**RE: SUBMISSION ON THE METROLINK ON BEHALF OF EARLDEV PROPERTIES UNLIMITED COMPANY IN RELATION TO PROPERTY AT 13-14 EARLSFORT TERRACE, REAR OF 15-18 EARLSFORT TERRACE AND 17-19 HATCH STREET LOWER, DUBLIN 2 (AND ALSO KNOWN AS 10 EARLSFORT TERRACE)**

**ABP Ref. NA29N.314724**

**Description - MetroLink Railway Order – Estuary through Swords, Dublin Airport, Ballymun, Glasnevin and City Centre to Charlemont, Co. Dublin**

Figure 1: Proposed Metrolink Tunnel Route against Existing Double Basement Structure

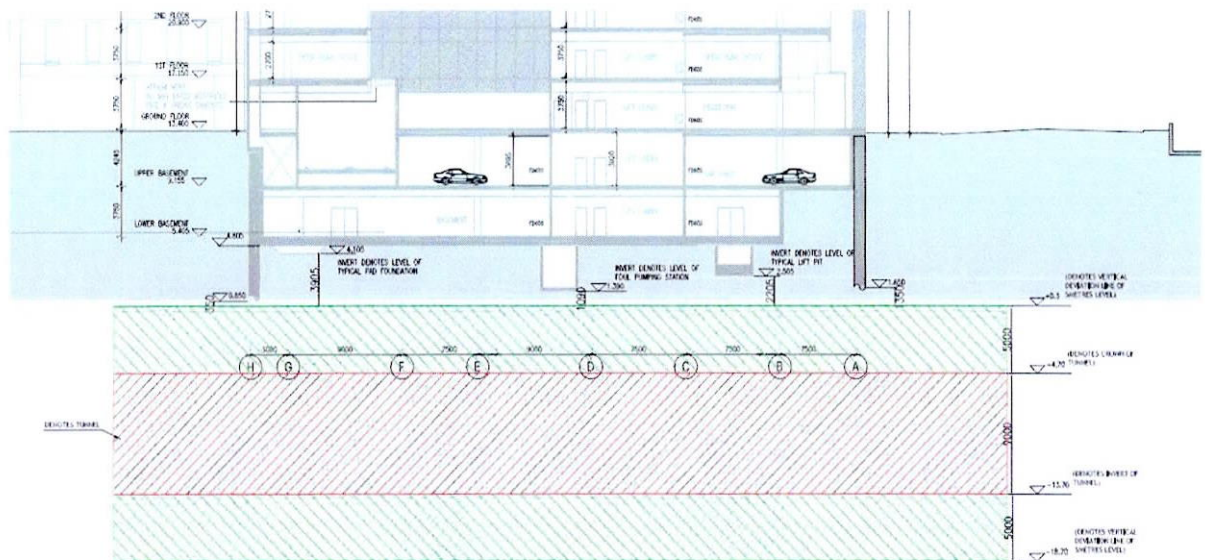
Due to the potential damage to the building, we request TII look to re-routing the proposed tunnel out onto the street of Earlsfort Terrace itself or drop the proposed tunnel level where building damage will not be a significant issue to this unique site along the proposed Metrolink route.

The extract below shows the proposed tunnel route with vertical deviations highlighted in relation to the existing basement structure, which clearly highlights both our clients and professional design team's concerns with its close proximity.

It is noted that all drawings in the Railway Order show the old building layout which was demolished circa 2014. This is a concern as the Arthur Cox Building at 13 and 14 Earlsfort Terrace has complex and sensitive basement, pile and façade structures in relation to the proposed tunnel. We expect the Arthur Cox Building to be replaced on all relevant drawings and the correct building parameters used in the assessment of the building going forward.

Photograph 1: Secant Piled Wall Supporting Perimeter Columns

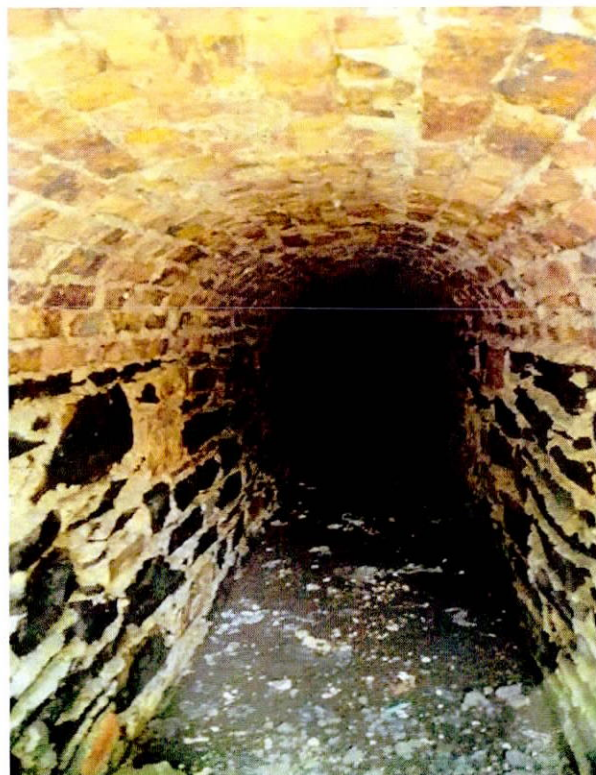
- i) The response above does not answer the query in our opinion.
- ii) We would expect to see a full copy of the detailed design package which allows for an independent assessment to be carried out by EPUC as they wish. We request confirmation of timelines from TII for this package.
- iii) The design should be site specific for 13 and 14 Earlsfort Terrace and take into account the concrete frame size/depth, the loadbearing secant pile walls, the water table and diverted River Stein culvert which runs under the building. We request that An Bord Pleanála condition same.
- iv) The secant piled wall supports not only temporary lateral loads, but the permanent column loads of the building (refer to Photograph 1) . The base level of the loadbearing piles are a significant concern in relation to the proposed tunnel depth and location.

Figure 2: Diverted River Stein Culvert

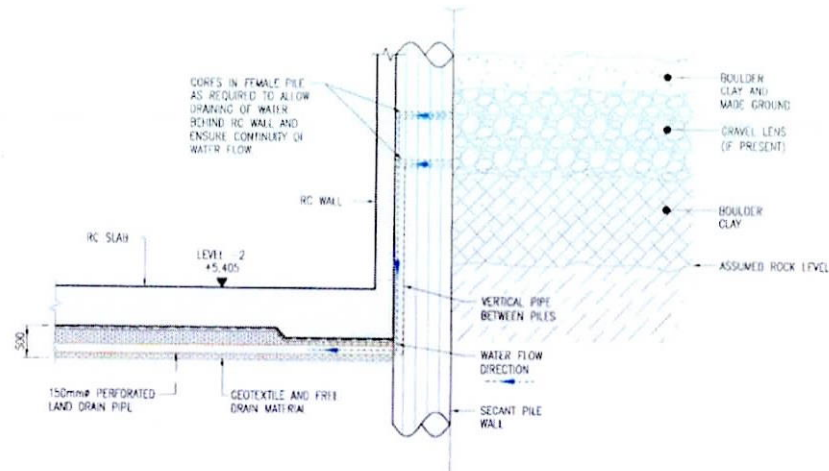
- vi) The construction of the secant piled wall required the culvert to be diverted under the new basement (refer to Figure 1).

## **Appendix A – Extract of Damage Assessment Report of Building and Other Assets**

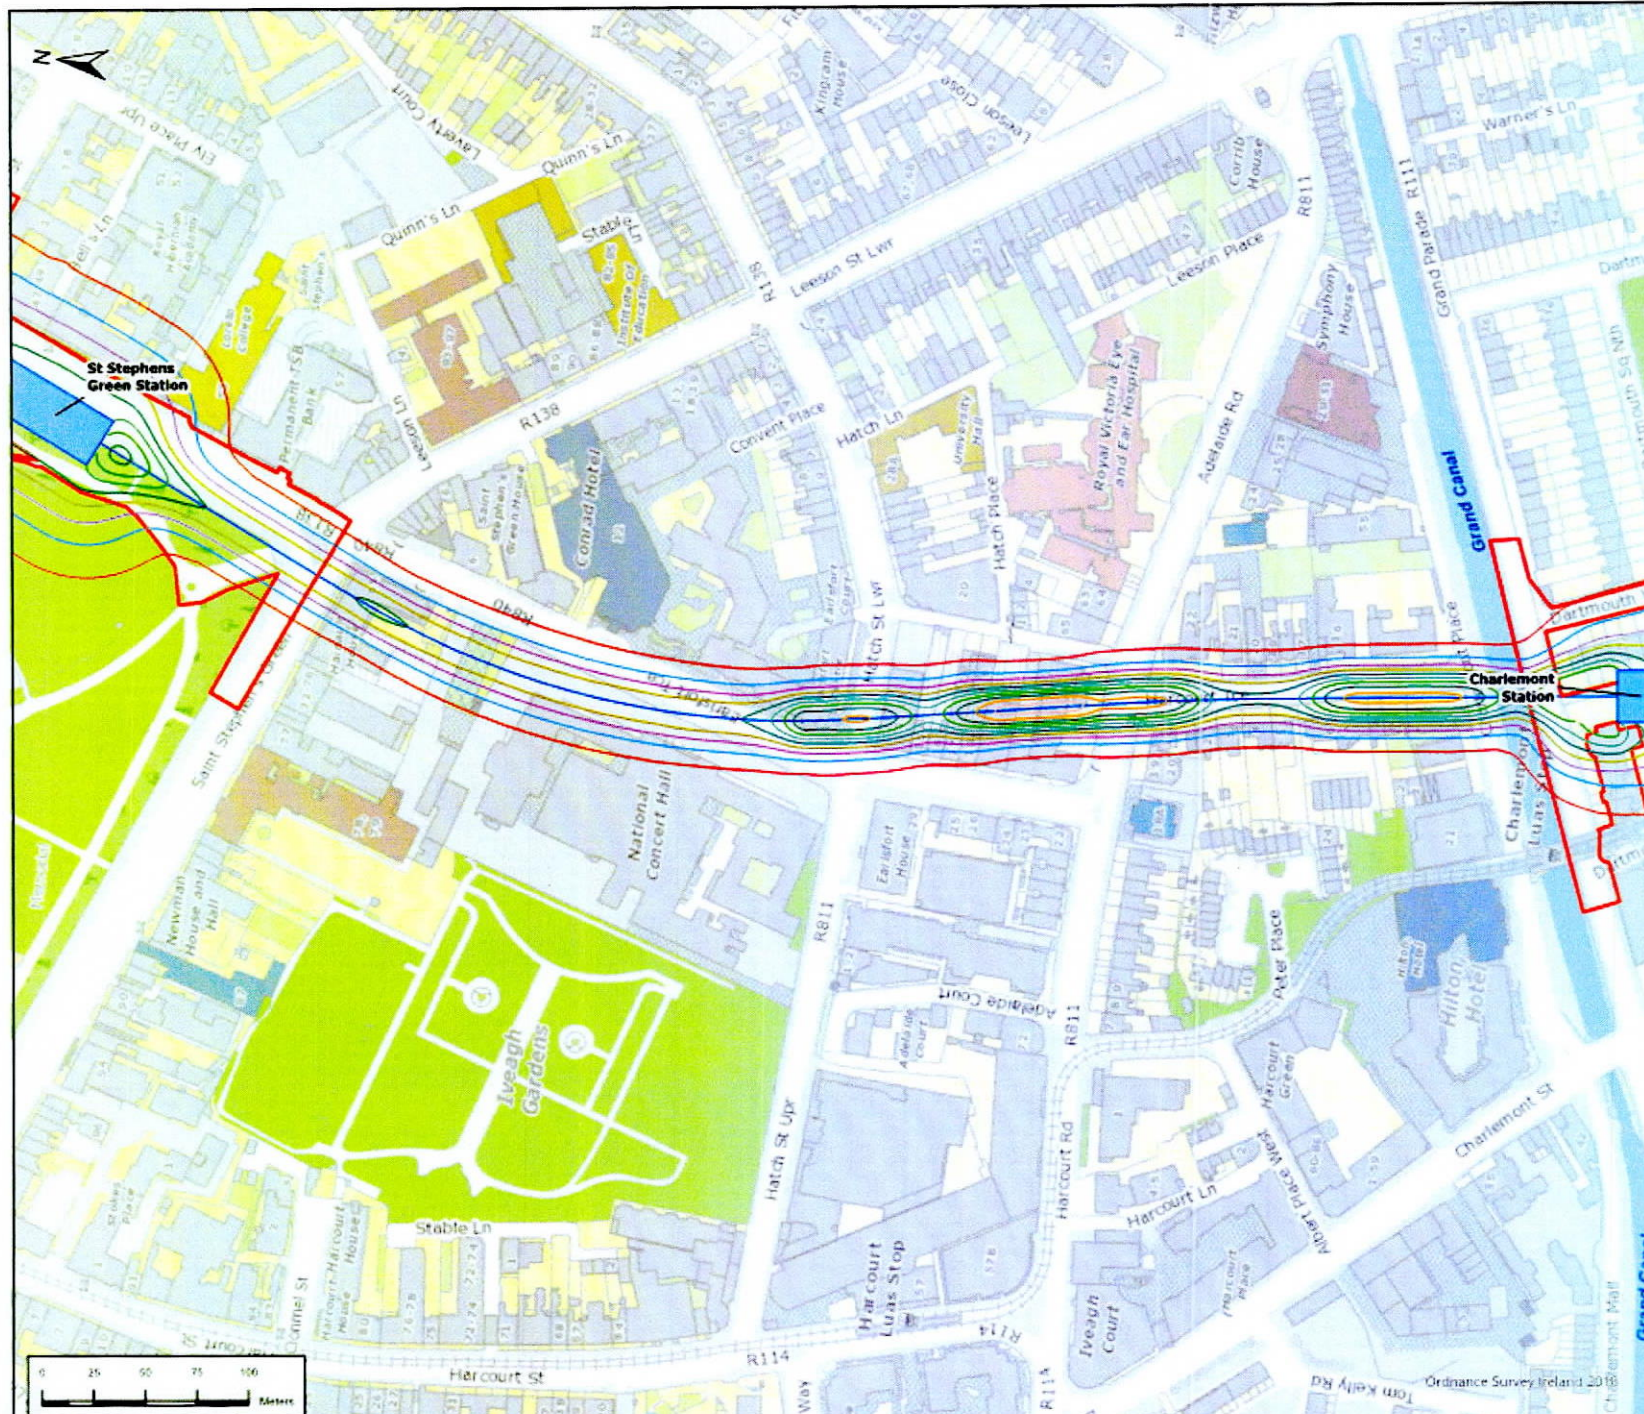
- i) The response above does not answer the query in our opinion.
  - ii) In the Damage Assessment Report of Building document, it places the Arthur Cox Building (B-238) in Damage Category B (Refer to Appendix A) . This conflicts with the above response, which states no structural impact has been predicted. This needs to be fully clarified by TII and request this is conditioned by An Bord Pleanála.

**Figure 1 – 5mm settlement contours at Aurthur Cox Building (≈Ch. 18950-19000) [Phase 1 Greenfield Settlements]**

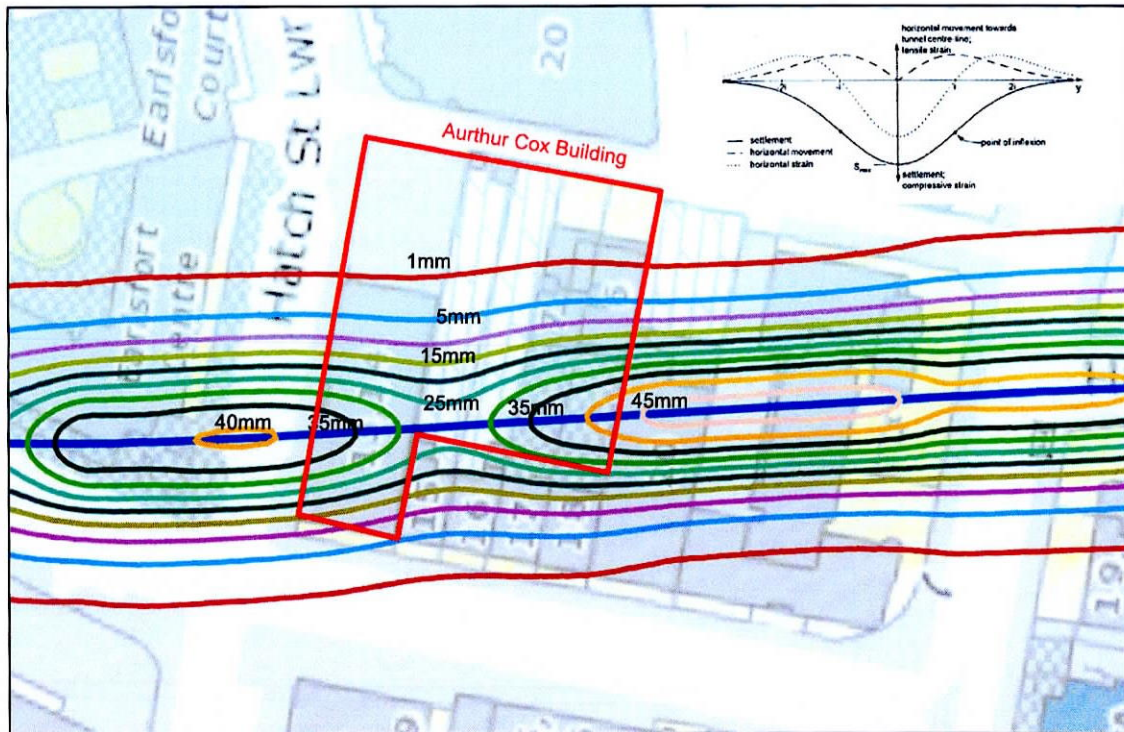
- Figure 1 of this letter shows the estimated greenfield settlements at the Arthur Cox Building. They are presented as 5mm contours for a trough of settlements centred about the tunnel with the maximum value at the tunnel centreline, as illustrated by the inset figure.

- The maximum settlements under the building are estimated as 25-45mm along the tunnel centreline, reducing to <5mm over a distance of about 25m to either side of the tunnel.

**Figure 2 – Interpreted geological profile (Appendix A20.9 of EIAR) at location of Aurthur Cox Building**

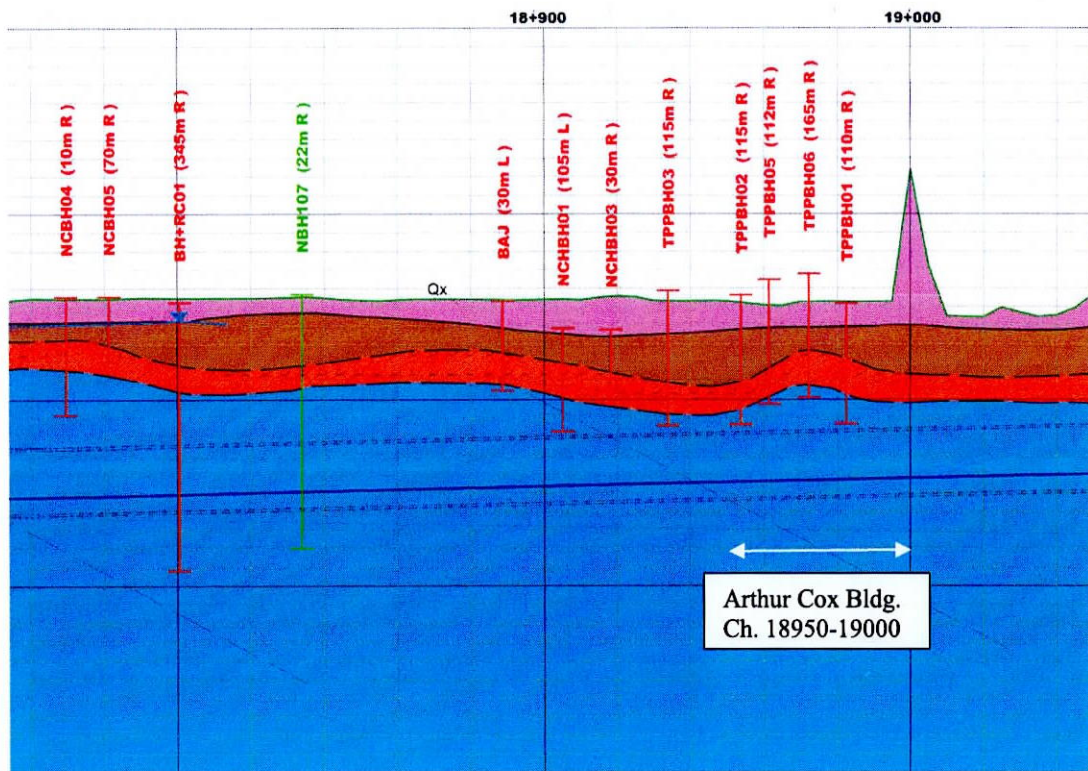
- The calculated maximum settlements are a function of the ground conditions at and above the tunnel horizon, and the estimated volume of ground loss which is expressed as a percentage of the face area of the 9.5m diameter tunnel as follows:
  - 1.5% where the tunnel is in rock but the depth of rock cover above the tunnel is <4.5m (i.e. 50% of the tunnel diameter); and
  - 0.75% where the tunnel is in rock with >4.5m cover.
- The range of maximum settlements calculated for the section of the tunnel under the Arthur Cox Building (approx. Chainage 18+900m to 19+000m) is directly proportional to the assumed % ground loss. Therefore, the settlement contours on Figure 1 reflect the following assumptions that were made in the calculations for the BDR, as summarised in Table 5.1 of the report:
  - Ch. 18900 to 18960: **1.50%**
  - Ch. 18960 to 18980: **0.75%**
  - Ch. 18980 to 19100: **1.50%**

Figure 2 of this letter shows the interpreted ground profile along the centreline of the tunnel from Appendix A20.9 of the EIAR.

**Figure 3 – Profile of tunnel, basement and secant pile wall at the Aurthur Cox Building**

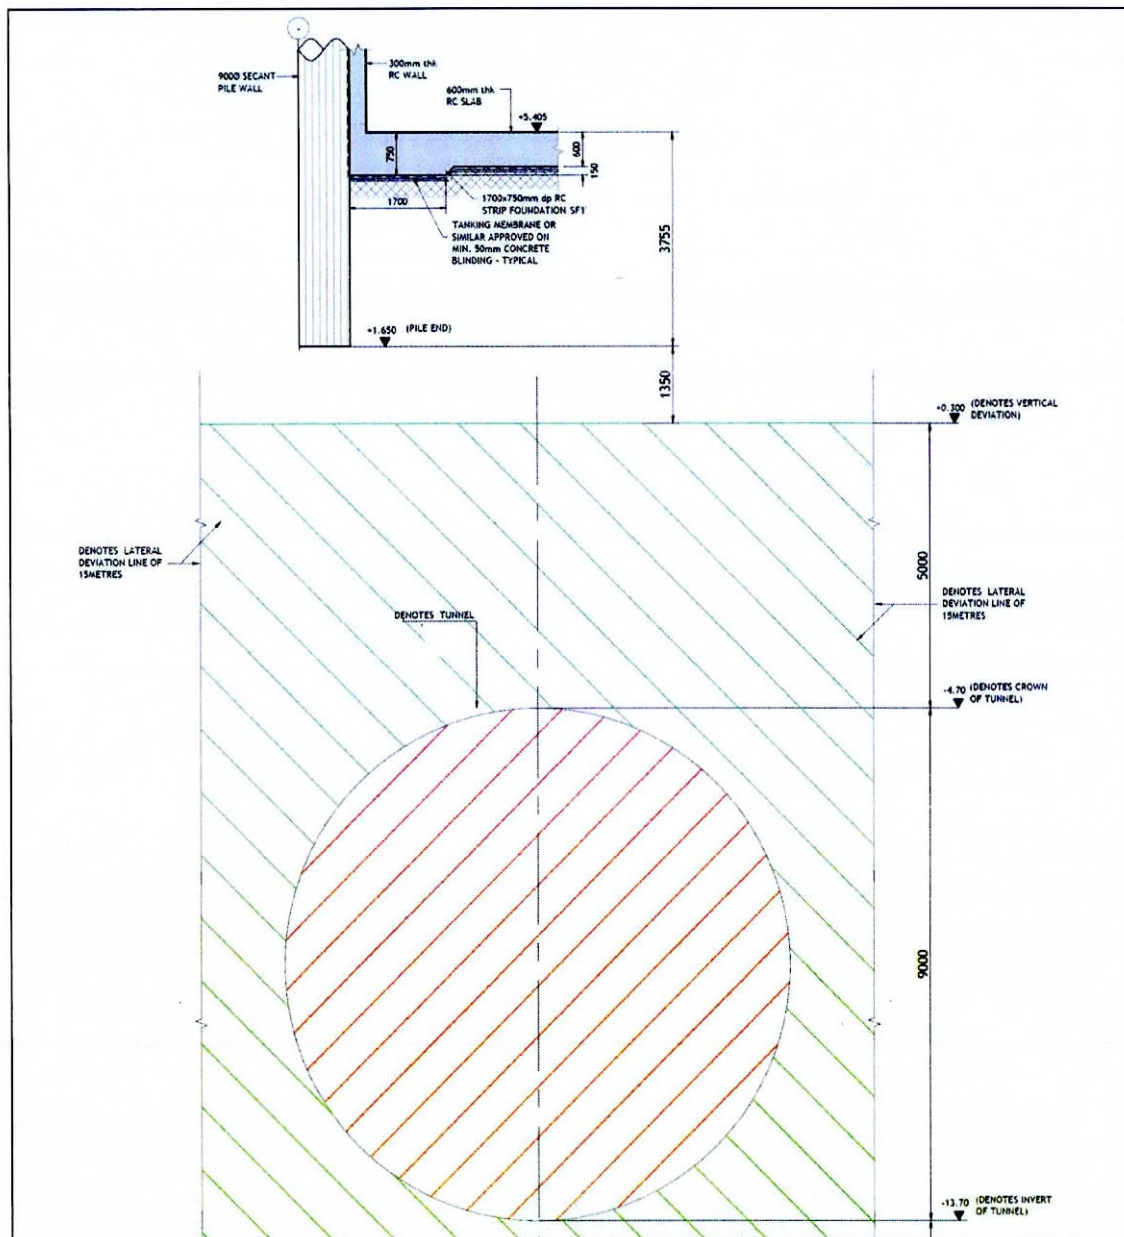
- Secondly, there is a perimeter secant pile wall around the basement, as shown in Figure 3, which is load bearing and supports parts of the façade and external columns. There is a high percentage of glass on the façade,

which would make it sensitive to differential settlements. Also, there is a concentration of load on the toe of the piles, which will be closer to the crown of the tunnel. This means that the settlement of the piles could significantly exceed the estimated greenfield settlements that could occur at the ground surface. Furthermore, if the tunnel alignment is raised to the upper Limit of Deviation (LOD), which is 5m above the alignment shown on the planning drawings, then the toe of the piles will be only approx. 1.35m above the crown of the tunnel. This is a significant concern as it could lead to excessive settlement and damage of the façade. It could also impact the stability of the tunnel bore during and after construction with concentrated loading on the tunnelling lining.

**Figure 4a – Distribution of greenfield settlements at ground level (18.0m cover) for 0.75% and 1.5% Volume Loss (VL)**

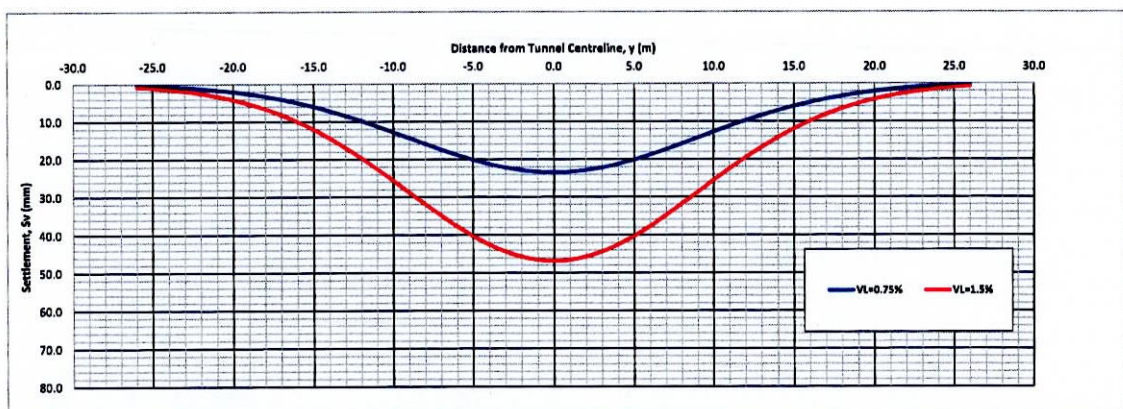
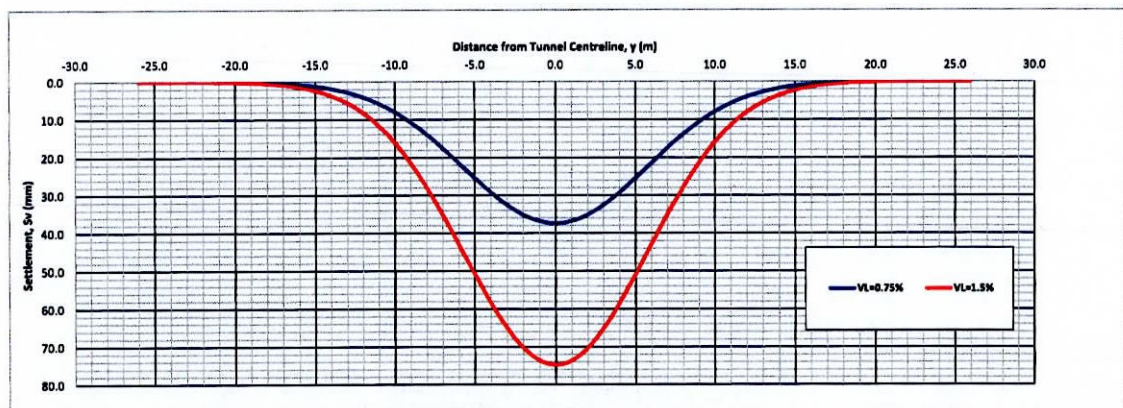
- Figure 4.1a and 4.1b show the calculated distribution of settlements at street level (18.0m cover to tunnel) and at the underside of the basement floor slab, where the depth of cover to the tunnel reduces to 9.5m. The settlements have been calculated for the same criteria in the Phase 2a preliminary assessment in the BDR assuming 0.75% and 1.5% ground loss for the range of interpreted ground conditions.

- The greenfield settlements at street level range from about 25–45mm and are spread out over a distance of 25m to either side of the tunnel centreline, as shown in the BDR. However, at the underside of the basement floor slab the maximum settlements for the same range in ground loss are  $\approx 50\%$  greater (37.5mm–75.0mm) and they are concentrated over a narrower corridor that extends only 15m to either side of the tunnel centreline.

## **Appendix D – Figure 12.2, Sheet 29 of 30, Construction Noise Assessment Locations**

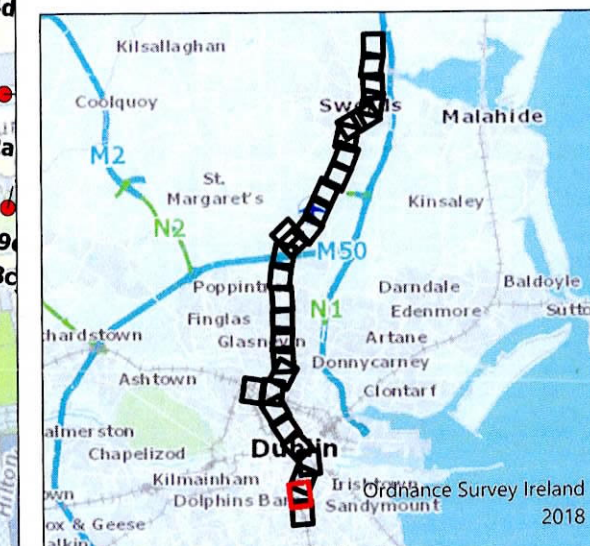
- iii) A further area of concern is Figure 12.2, Sheet 29 of 30, Construction Noise Assessment Locations (Refer to Appendix D) which shows there were no construction noise receivers placed on or surrounding our clients building. This is a huge concern as we cannot see how the predicted noise limits can be determined without a noise receiver on our client's building or surrounding buildings.
